Re: Town of The Pas Lagoon – Notice of Alteration

The Town of The Pas is requesting approval from Manitoba Conservation and Climate for a minor alteration to the Town of The Pas lagoon Licence (No. 3313). The alterations include:

Short Description of Alteration *(max 90 characters):*
Change SAGR liner material from HDPE geomembrane liner to clay.
Wet Weather flows

TITLE: PROPOSED LAGOON UPGRADE LAYOUT PLAN

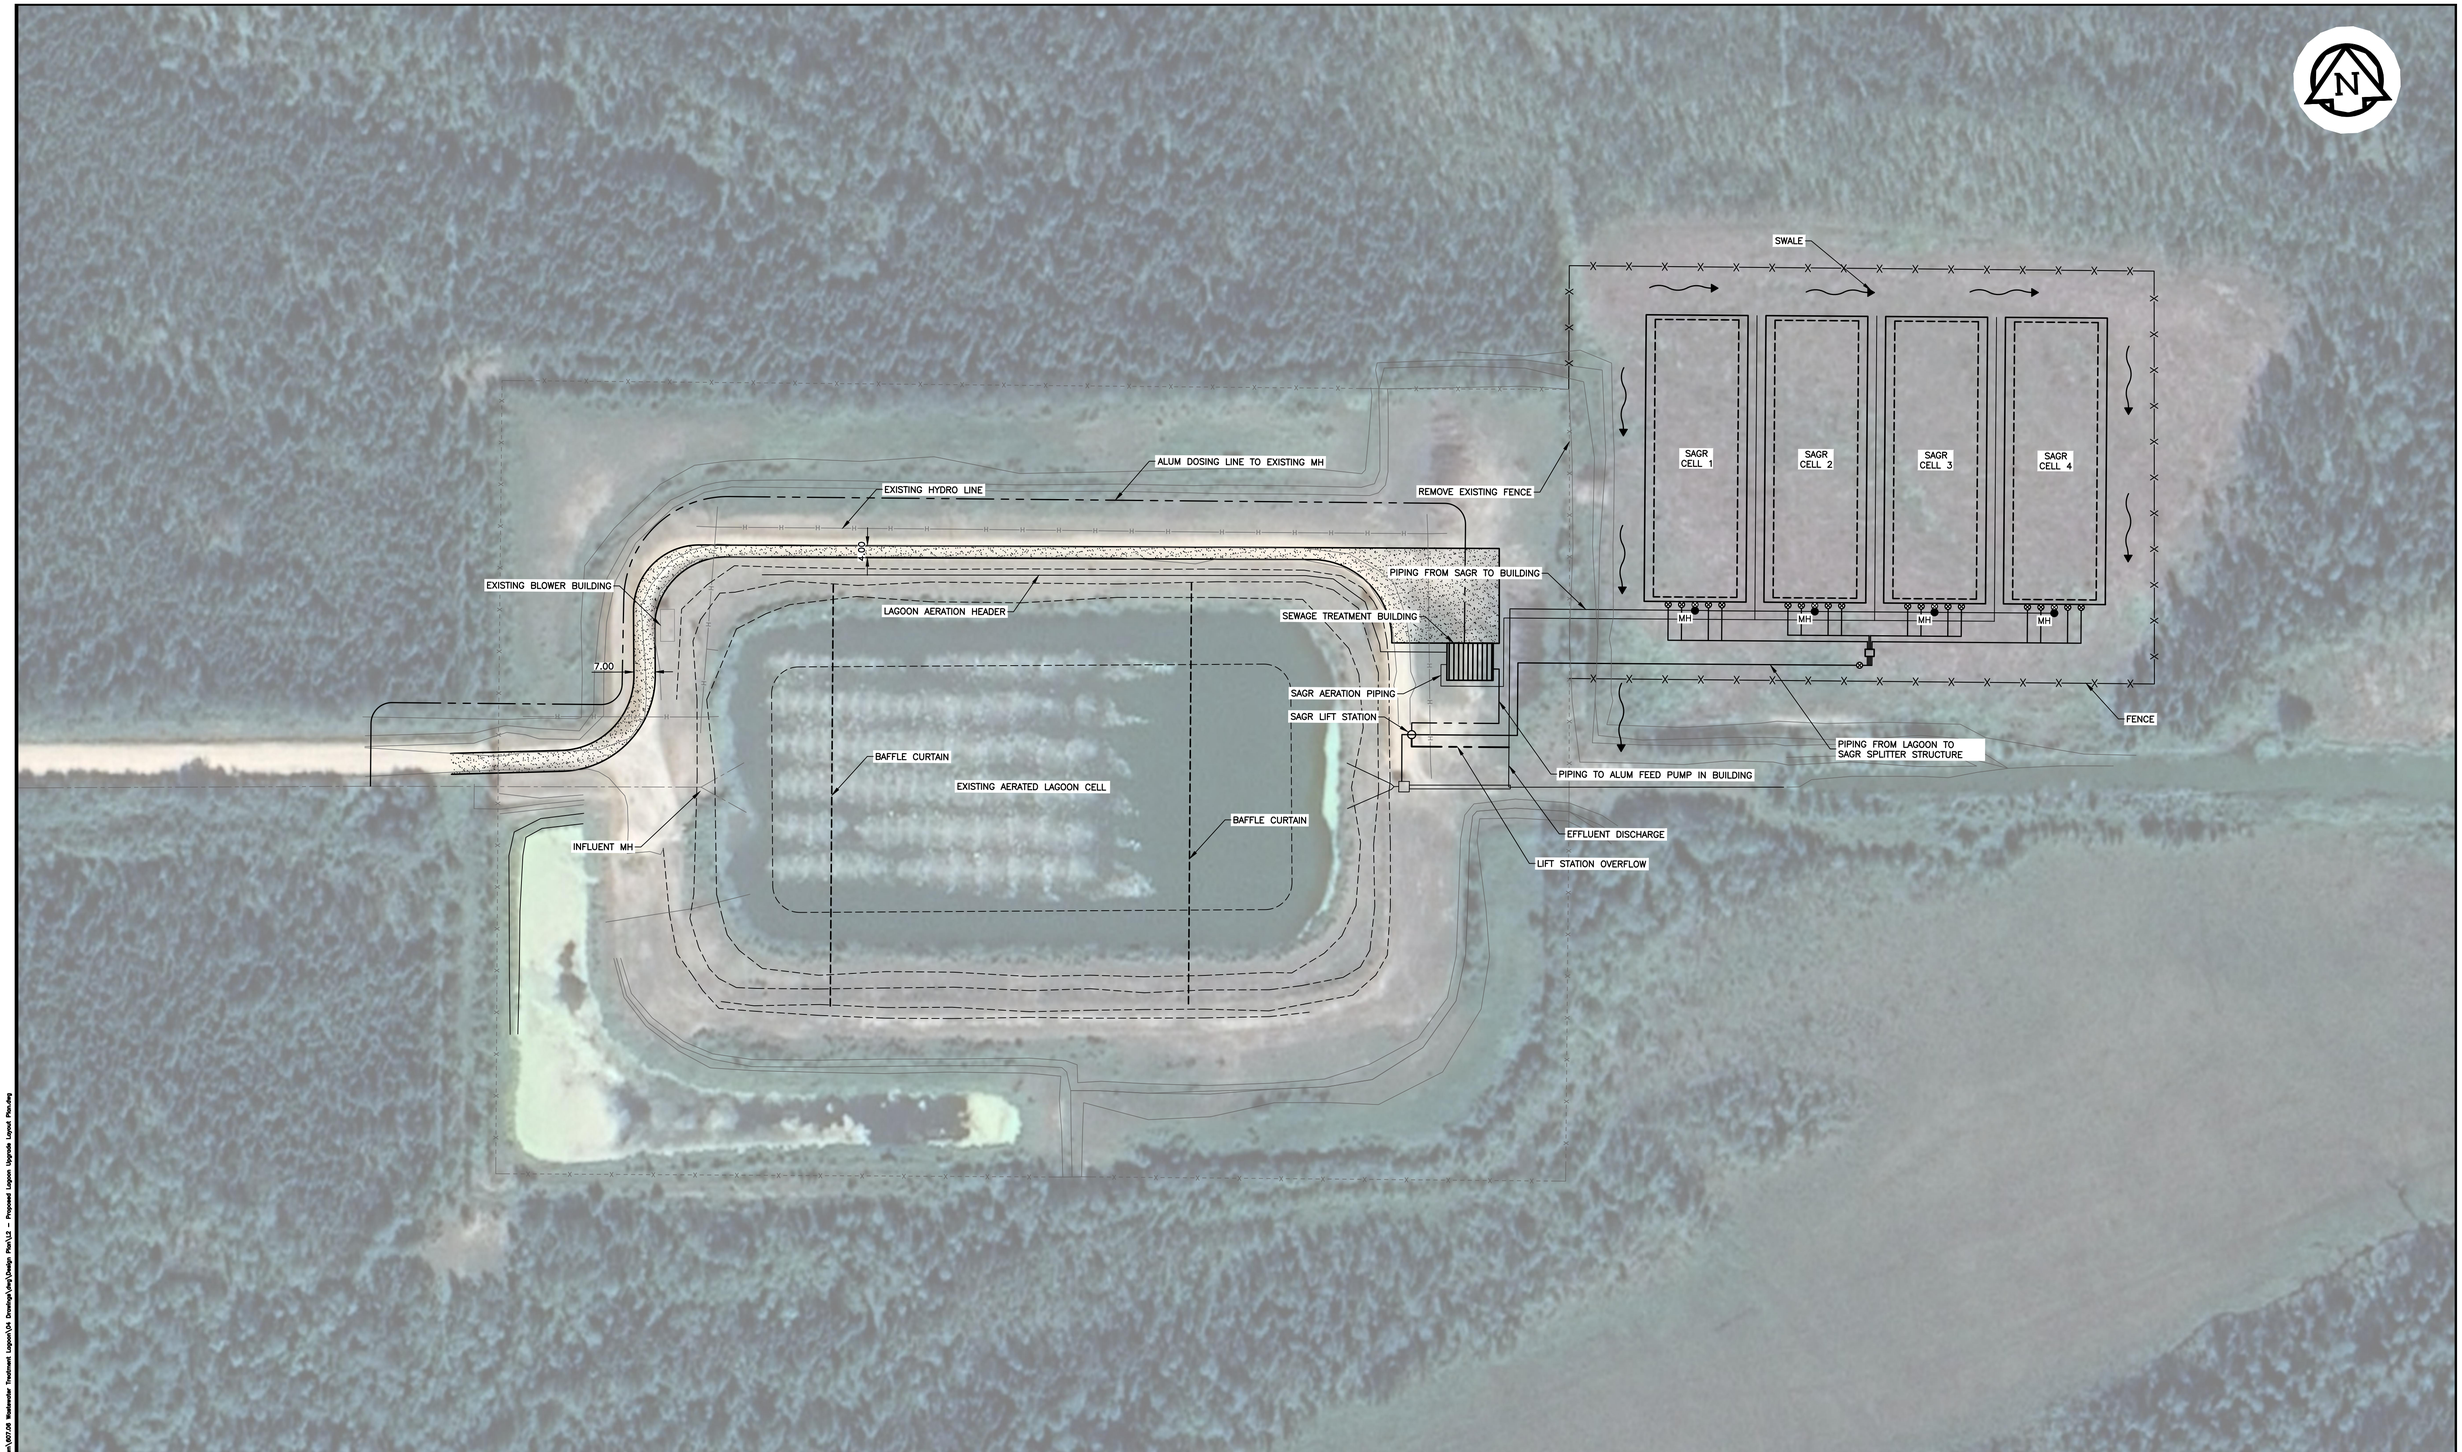
At the time the EAP was prepared, the proposed design included the addition of a baffle curtain to provide more consistent flow through the existing lagoon, resulting in less short-circuiting, more efficient treatment and higher CBOD removal. As the design has progressed to the selection of treatment equipment, the successful proponent, Nexom, has proposed a second baffle curtain.

The lagoon will be configured to have a complete mix aeration zone, followed by a partial mix aeration zone and a settling zone. This configuration will provide more efficient BOD treatment, which allows for a more efficient SAGR footprint after the lagoon. The aeration system will be configured so that the Town can operate the complete mix zone as a partial mix zone in early years, provided that effluent parameters are still met, to reduce power consumption and operating costs. Overall, this change has no impact on the Town's ability to meet the effluent quality described in the current Licence. Please see the attached JRCC plan L2 showing the proposed lagoon layout
